METROPOLITAN GOVERNMENT OF NASHVILLE AND DAVIDSON COUNTY

STAFF RECOMMENDATION
3719 Princeton Avenue
December 17, 2014

Application: New construction - addition
District: Richland-West End Neighborhood Conservation Zoning Overlay
Council District: 24
Map and Parcel Number: 10405016000
Applicant: Collins Smith, Owner
Project Lead: Sean Alexander, sean.alexander@nashville.gov

Description of Project: The applicant proposes to enclose a left-front screened porch with glass windows, to enclose a rear-right corner porch with lap siding, and to construct a rear addition.

PROPOSED SITE PLAN
 Scale: 1/8" = 1'-0"

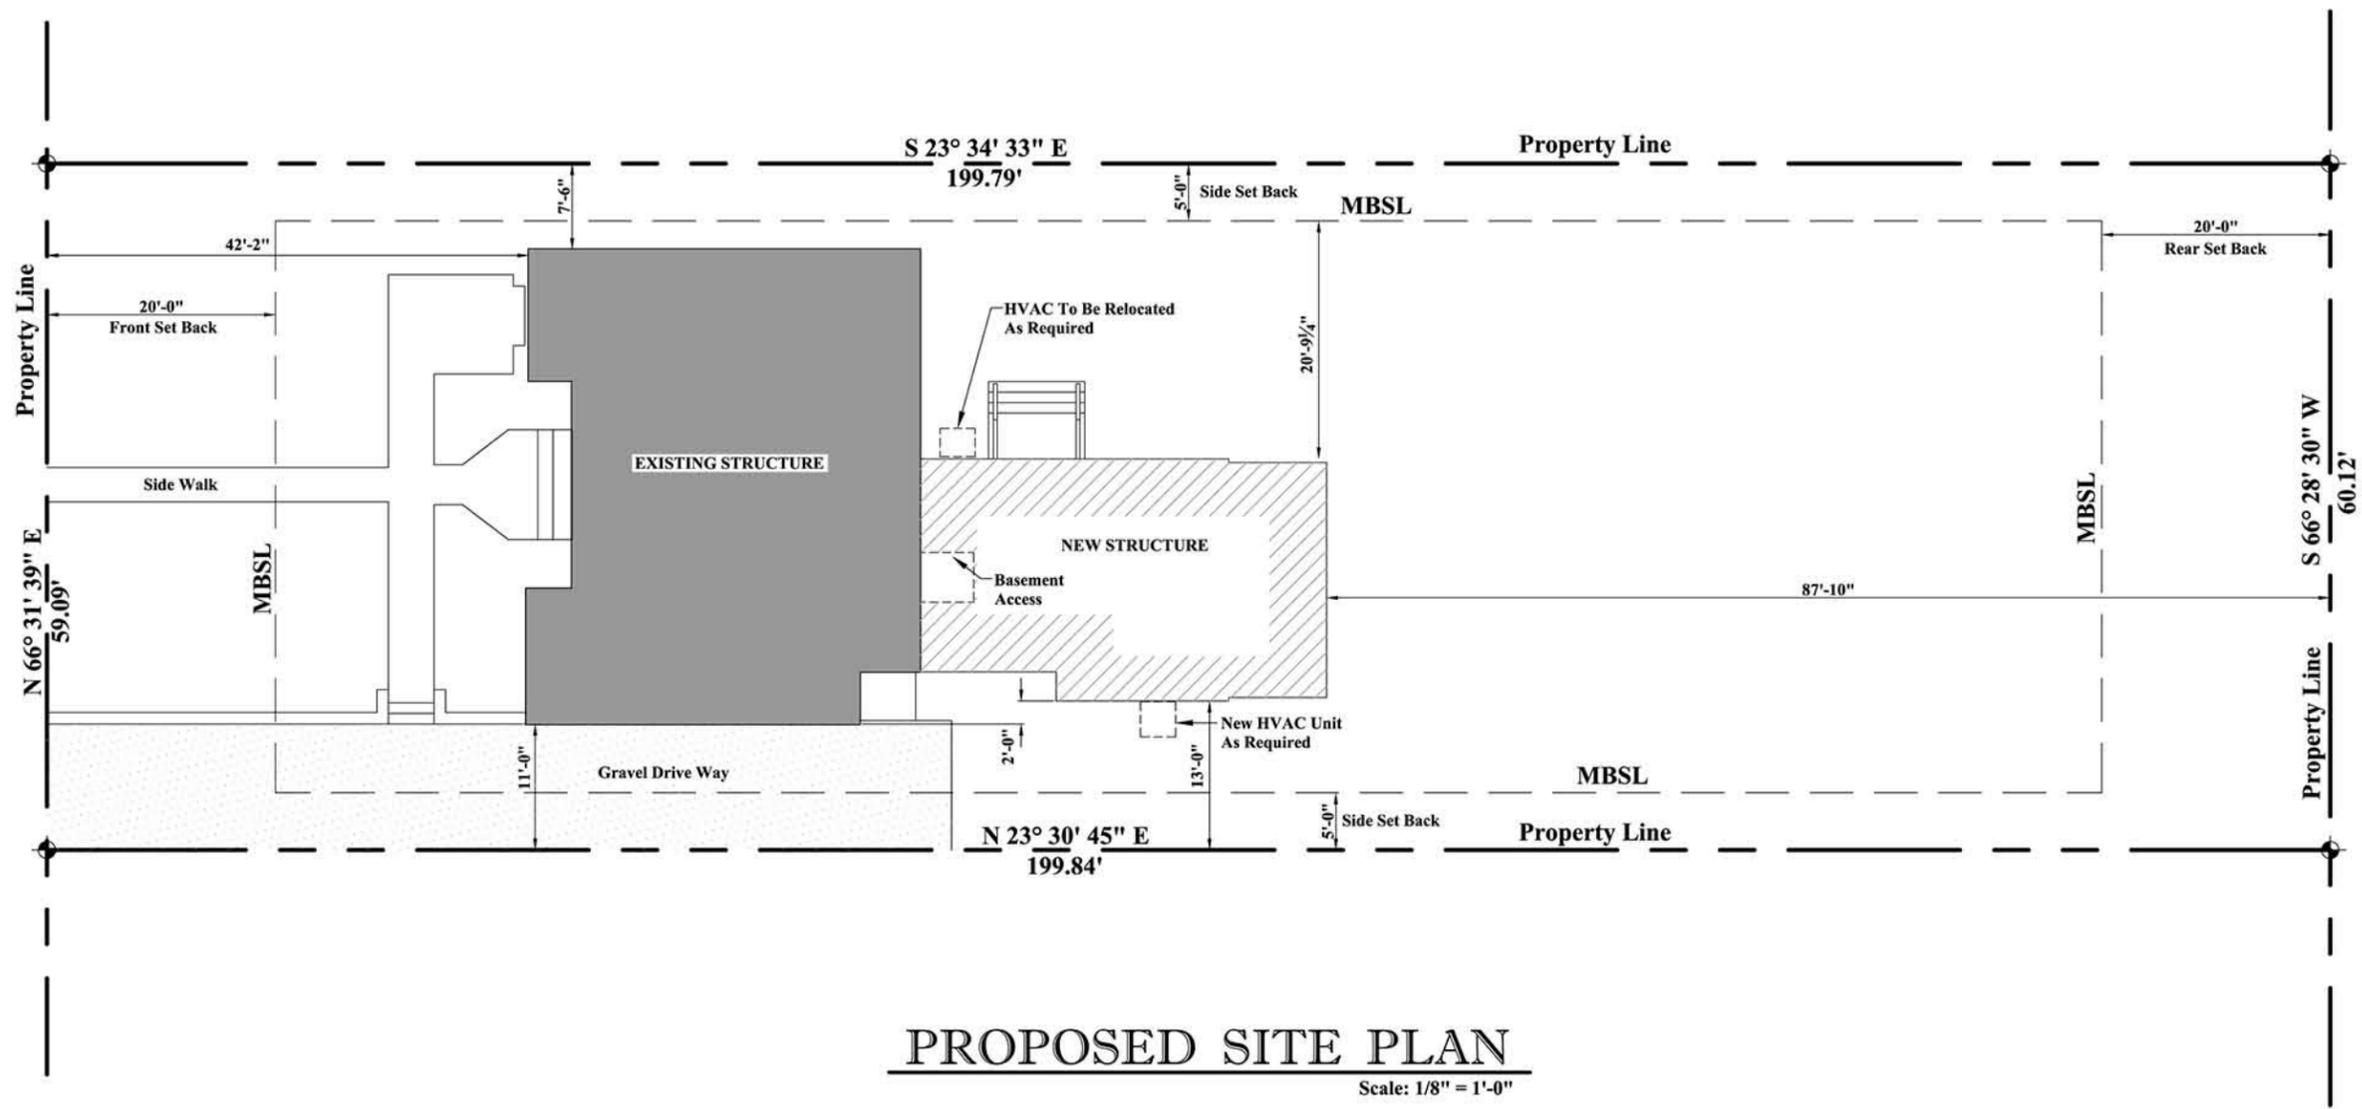
The addition will be at the rear of the structure, sitting in from the right side of the house by two feet (2'), and then continuing back forty feet (40') to the rear. The addition will be roughly half the width of the house, sitting in eighteen feet (18') from the left side of the building.

Setback & Rhythm of Spacing: Sitting in two feet (2') from the original house on the right side, along which there is an existing driveway, the setback from the right property line will be thirteen feet (13'). Staff finds that the addition is sufficiently separated from the adjacent structure so as to not interrupt the established rhythm of spacing between existing houses. The addition will also meet the setbacks on the left side and rear. The project meets section II.B.1.c.

PROPOSED RIGHT ELEVATION

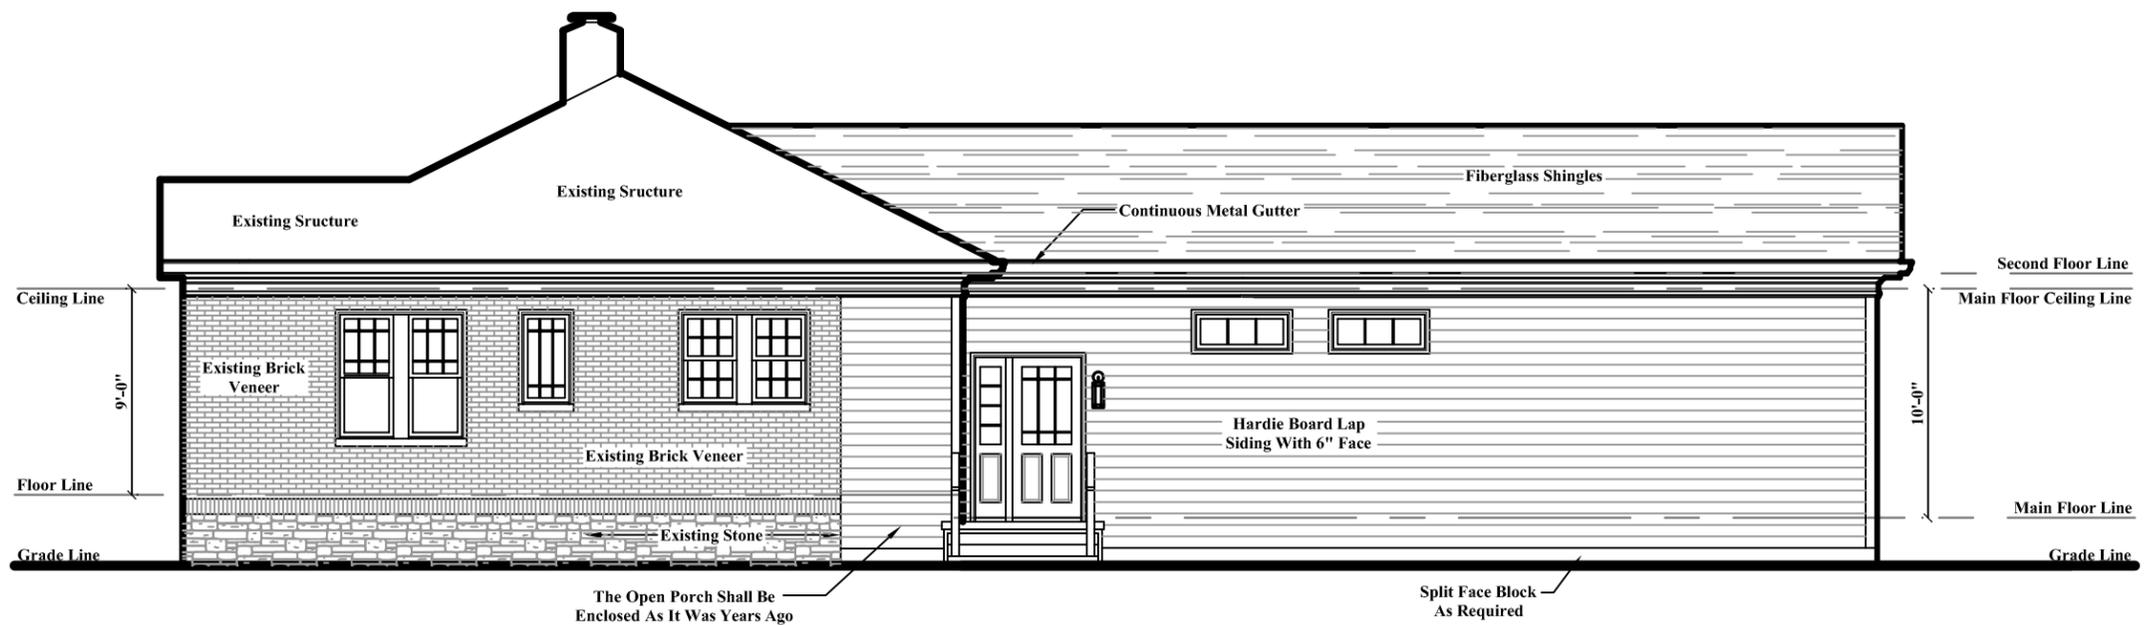
expanses of wall space without a window or door opening. Staff finds that the proportion and rhythm of windows on the right side of the addition would not be compatible with the historic house. The windows on the left side of the proposed addition will not be visible because the addition sits in eighteen feet from the side of the existing structure. With a condition that additional windows are added on the right side of the addition, Staff finds the project's proportion and rhythm of openings to meet Section II.B.1.g.

Staff recommends approval of the front-left and rear-right porch enclosures and the construction of the proposed rear addition, with the conditions that additional windows are added on the right side of the addition, and that all windows and doors are approved by Staff. Meeting that condition, Staff finds that the proposed work meets the design guidelines for the Richland-West End Neighborhood Conservation Zoning Overlay.
